# **Proposed Marlborough Environment Plan**

**Section 42A Hearings Report for Hearing Commencing  
30 April 2018**

**Report on Submissions and Further Submissions  
Topic: 17 - Subdivision**

**Report prepared by  
Ian Sutherland  
Senior Resource Management Officer**

Figure 3.14 – Flat channel or yard sump

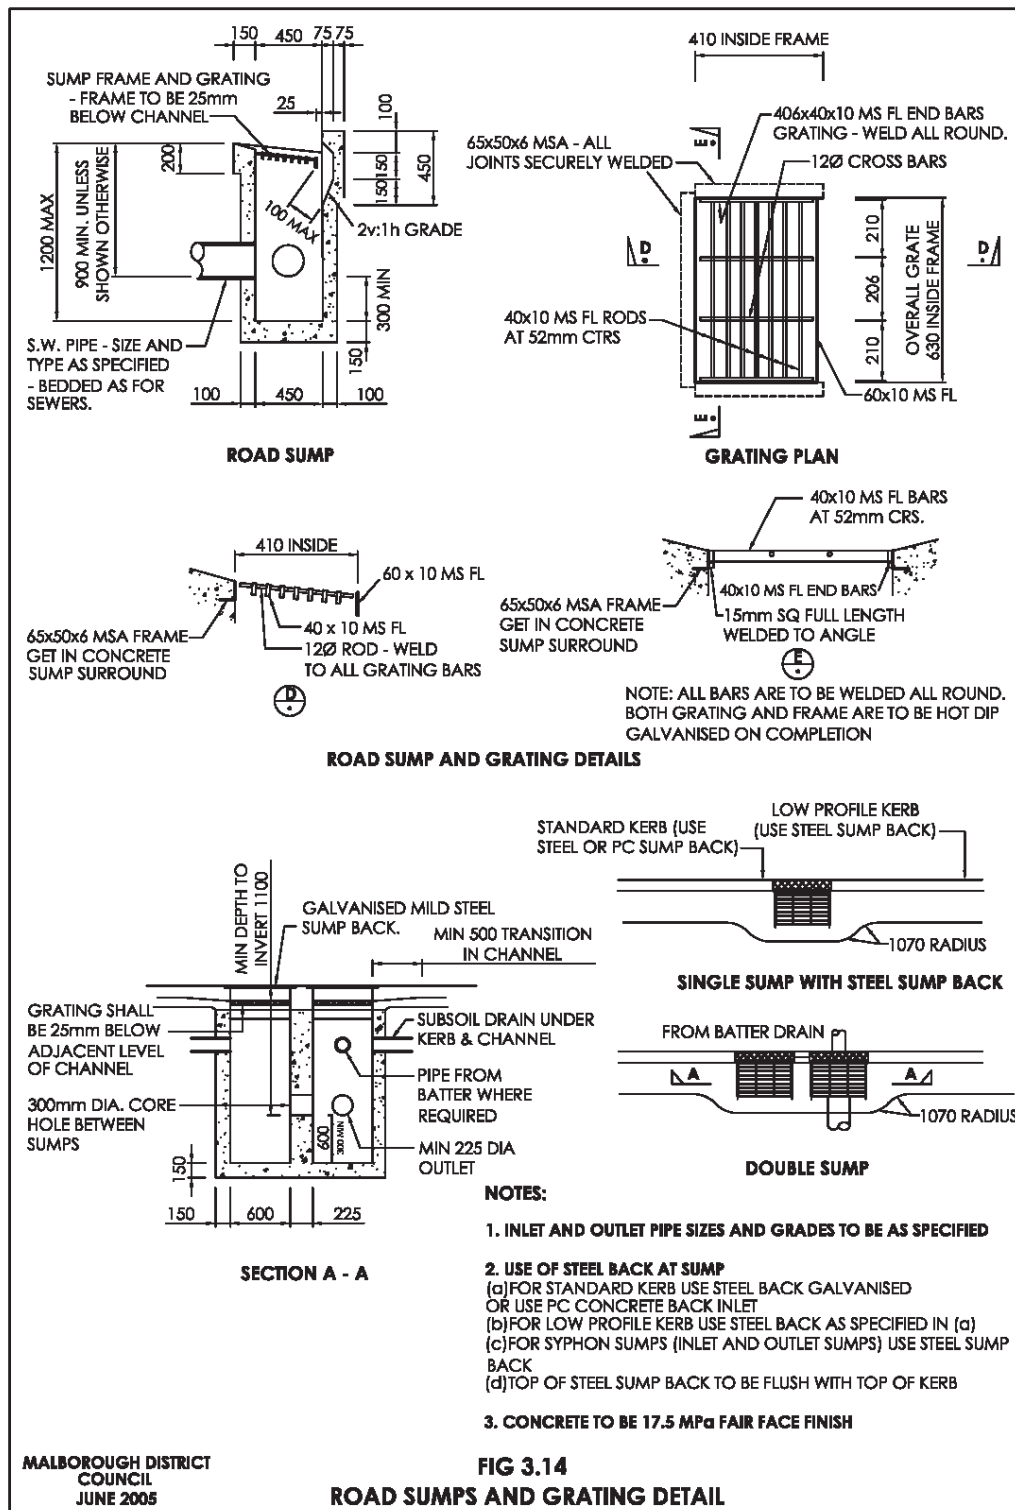
26. Replace Figure 3.14 – Flat channel or yard sump p 77 with Figure 3.14 Road Sumps and Grating Detail as follows:

Figure 3.19 Local AP40 Basecourse Envelope

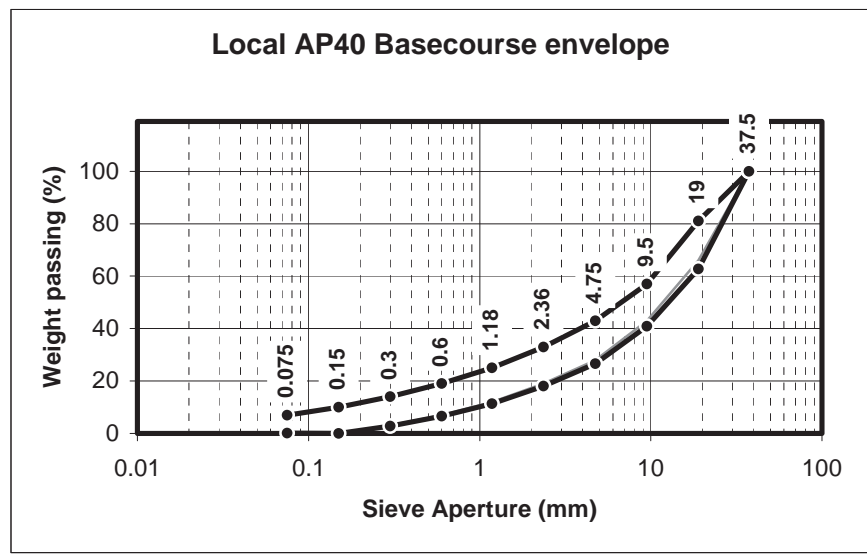
30. Insert *Table 3.6A – Particle Size Distribution Envelope Limits for an Individual Sample* and *Figure 3.19 Local AP40 Basecourse Envelope* as follows:

**Figure 6.1 – Conceptual hydraulic operation of a gravity main**

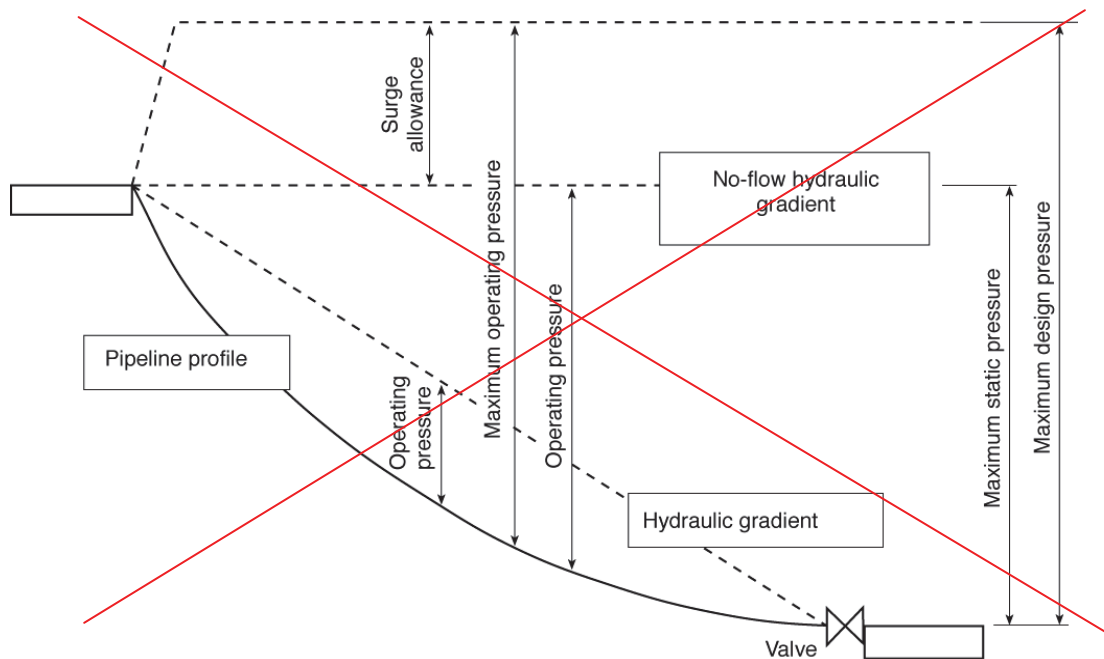
75. Figure 6.1 *Conceptual hydraulic operation of a gravity main* p146 is replaced with the following
